HISTORIC AND DESIGN REVIEW COMMISSION

May 01, 2019

HDRC CASE NO: 2019-223
ADDRESS: 517 E HOUSTON ST
LEGAL DESCRIPTION: NCB 422 BLK 26 W 26 FT OF 5 ARB A2
ZONING: D, H, HS
CITY COUNCIL DIST.: 1
DISTRICT: Alamo Plaza Historic District
LANDMARK: Rosenberg, Frank Building
APPLICANT: Michael Litofsky
OWNER: Michael Litofsky
TYPE OF WORK: Front Facade Reconstruction, including removal of ClearBoarding for compliance
APPLICATION RECEIVED: April 17, 2019
60-DAY REVIEW: June 16, 2019
CASE MANAGER: Huy Pham
REQUEST:

The applicant is requesting a Certificate of Appropriateness for approval to construct the storefront at 517 E Houston in accordance with plans approved by the HDRC on May 20, 2015 and a timeline of compliance. This request is a result of a municipal court case filed for the installation of ClearBoarding prior to approval.

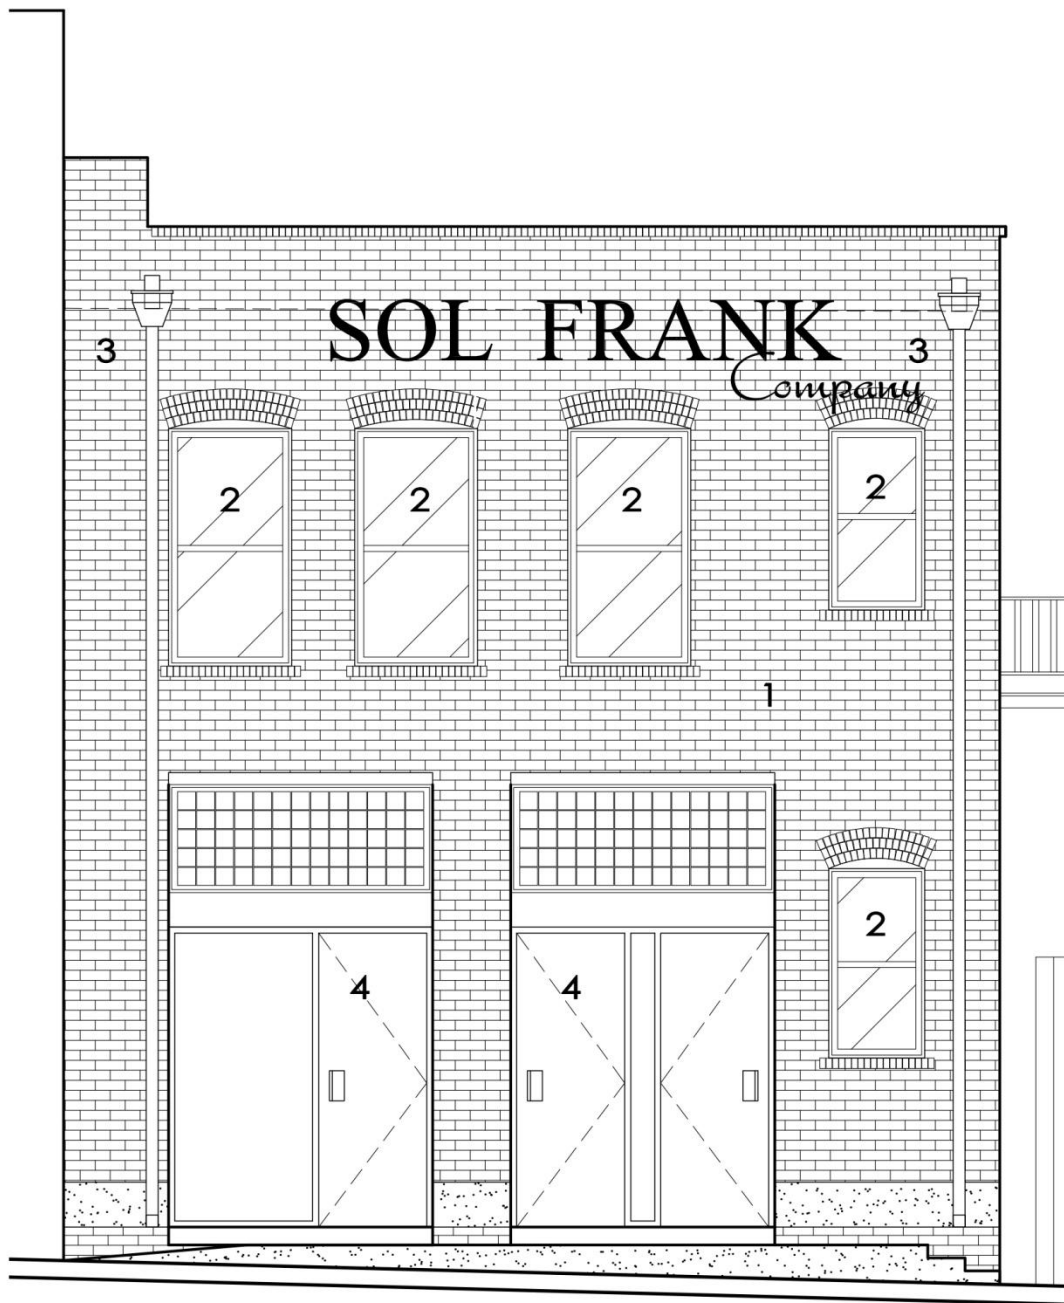
- n. **NEW DOORS** - The applicant has proposed to install two (2) new doors on the Peacock Alley façade. While this is the rear of the building, in this instance the rear is proposed to be treated as the front also. The Guidelines for Exterior Maintenance and Alterations 6.A.i. does not recommend that new entrances be created where visible from the public right of way. This proposal is not consistent with the Guidelines. Staff recommends that the applicant keep the existing door openings and widths.

- 1 CLEAN AND RESTORE EXISTING BRICK
- 2 REPLACE WINDOWS
- 3 RESTORE SCUPPER, DOWNSPOUT AND DOWN LEADER
- 4 NEW DOORS

Staff recommends approval of storefront reconstruction from the 2015 approved plan set (itemized in finding e, excluding rear door modifications) based on findings c through n with the following stipulations:
